Watts Bar Nuclear Plant, Unit 2
NRC Docket No. 50-391

Subject: Watts Bar Nuclear Plant (WBN) Unit 2 – Request For Additional Information (RAI) Regarding Individual Plant Examination (TAC No. ME3334)

Response to IPE RAI 14

Figure 1: WBN U2 Results of Truncation Evaluation for LERF – Updated HRA Dependency

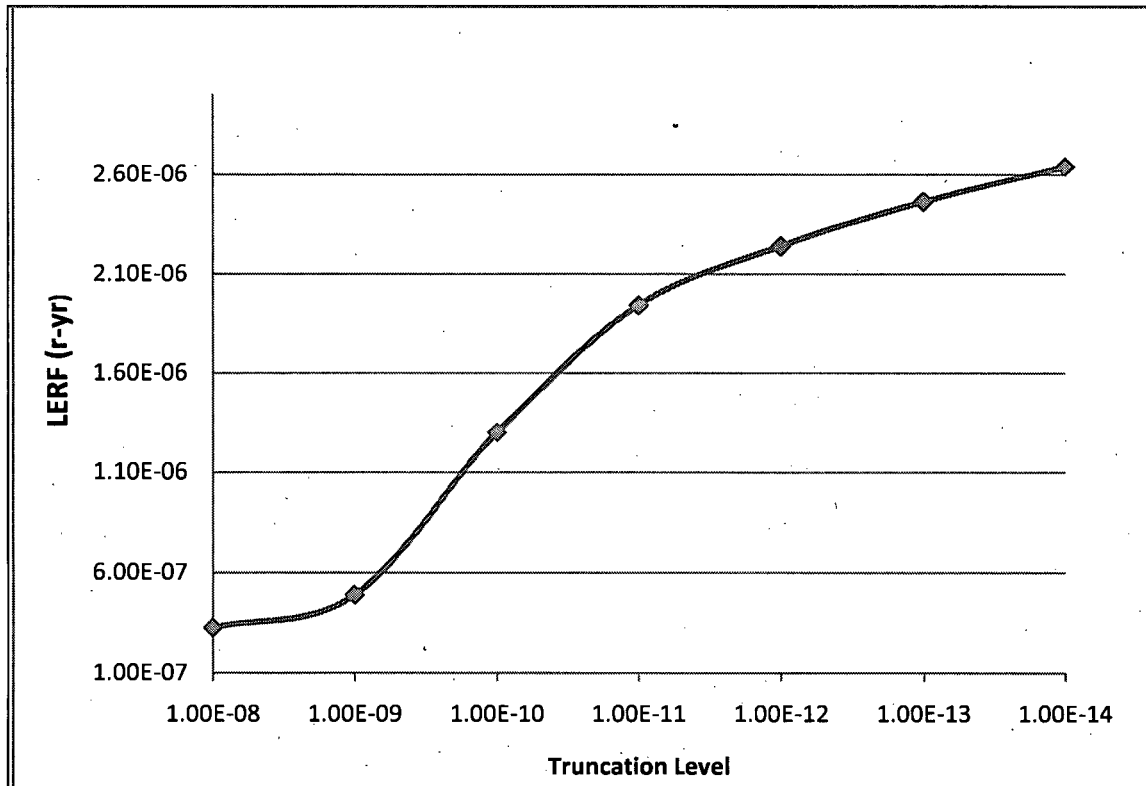
Inappropriate truncation can result in significant accident sequences being erroneously eliminated; SRs QU-B3/LE-E4 provide the requirements for acceptable truncation. Provide the technical bases for using the same truncation limit for LERF; that is, provide the change in LERF if a lower truncation limit was issued. If the change in LERF is greater than 5 percent, identify what sequences were eliminated (Reference F&O 3-1).

Figures 1 and 2 clearly illustrate decreasing changes in LERF following successive reductions in the truncation value. These results demonstrate convergence of the model with the updated recovery file and that no significant cutsets have been inadvertently eliminated. As an independent perspective, we also received feedback from EPRI on the WBN LERF result, and they recommended quantifying the WBN LERF results at 1E-13/r-yr based on the small relative change in LERF. A representative from EPRI also noted that, at this truncation level, the Level 2 model uncertainty is likely to dominate the results.
